PROJECT: Webster University ISP Building St. Louis, MO	MISSOURI TERRAZZO COMPANY 726 N. Euclid Avenue St. Louis, Missouri 63108	MoT - TZ 1 - 2
General Contractor: Paric Corporation St. Louis, MO		10-19-16

WEBSTER UNIVERSITY, INTERDISCIPLINARY SCIENCE BUILDING
1100 CLARK AVE
ST LOUIS, MO

SUBMITTAL IDENTIFICATION SHEET

096623-002
CONTRACTOR / CM SUBMITTAL NO.

Terrazzo Expansion Joint Detail n.t.s.

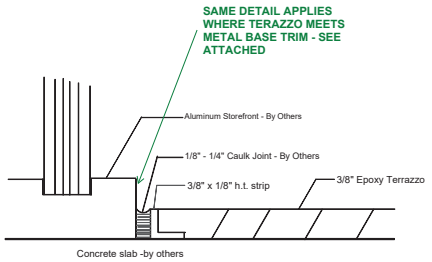
ADVISE ARCHITECT OF LOCATIONS. PROVIDE CRACK REDUCTION TREATMENT AT LOCATIONS NOT ACCEPTABLE TO ARCHITECT

First Floor - Terrazzo Floor Layout Drawing 1/8"=1'-0"

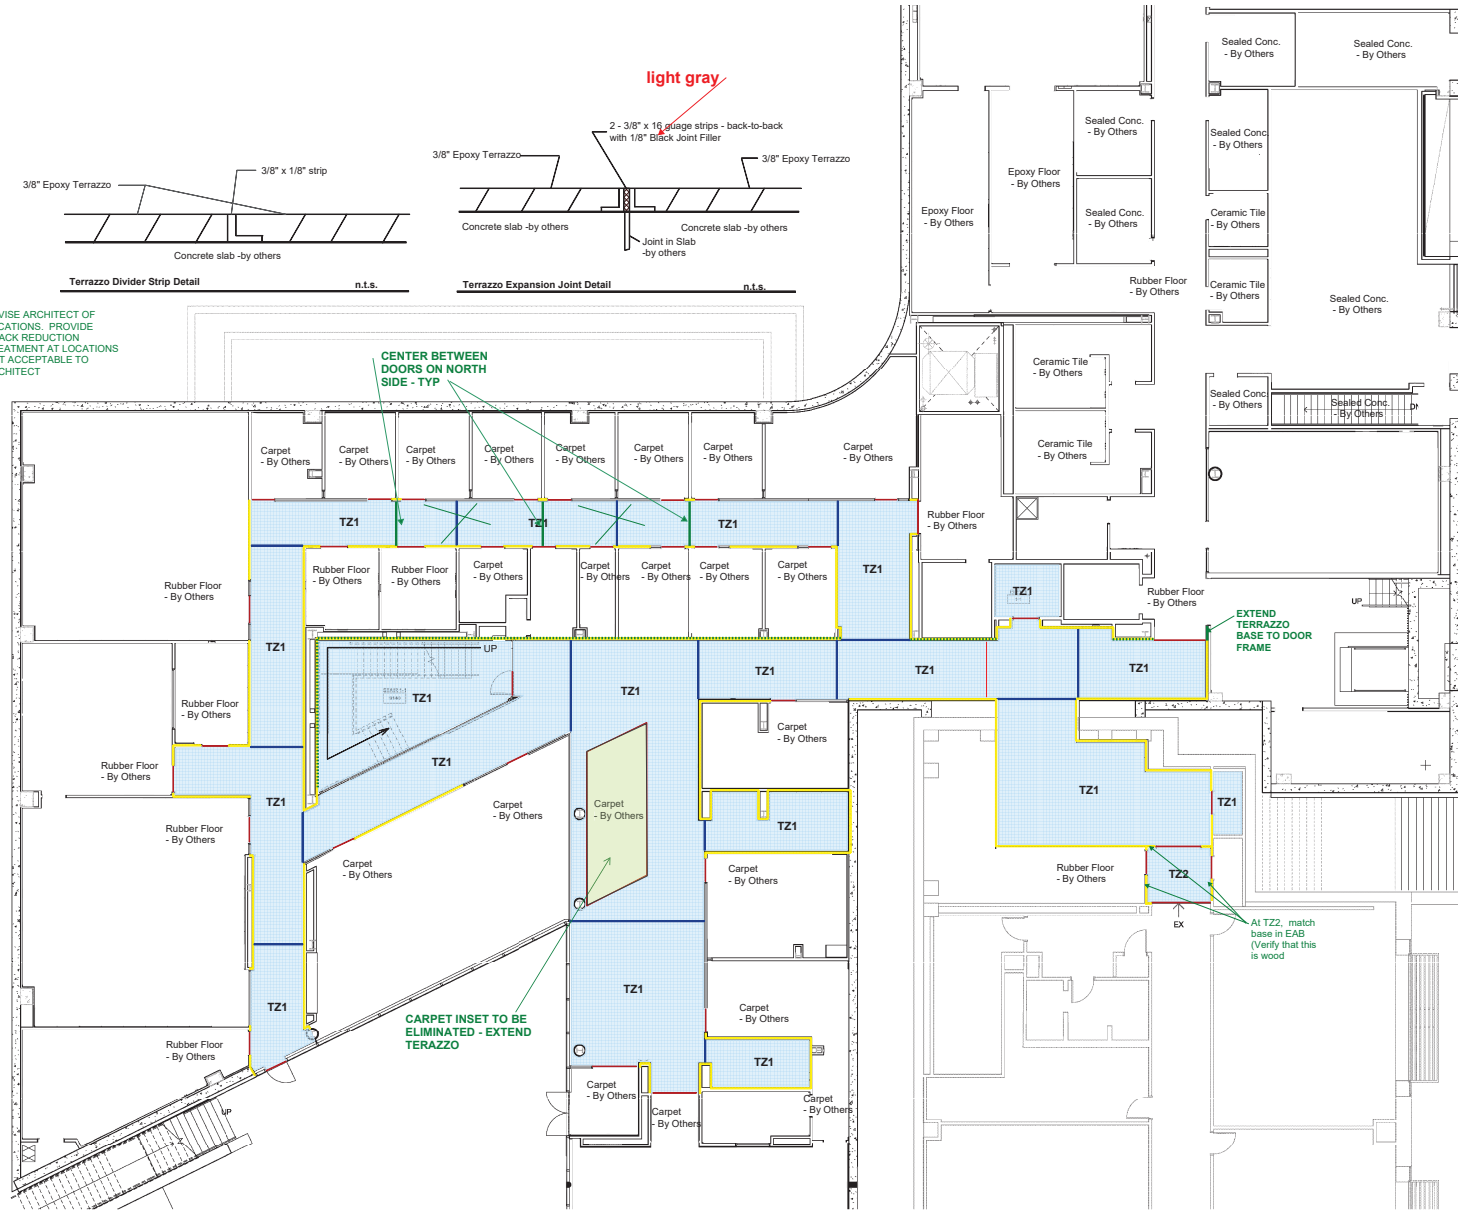
CHANGE TO PRECAST TERRAZZO BASE

Terrazzo wall base at this location see change in detail

Metal Base at Wood Paneling per A0605 and A0606 Detail 3-a0801 - Terrazzo Base not required

proposed revised location of expansion joint/ divider strip

Note: Change base to 4" precast terrazzo base to match poured in place as indicated on drawings. See changes to extent of base required
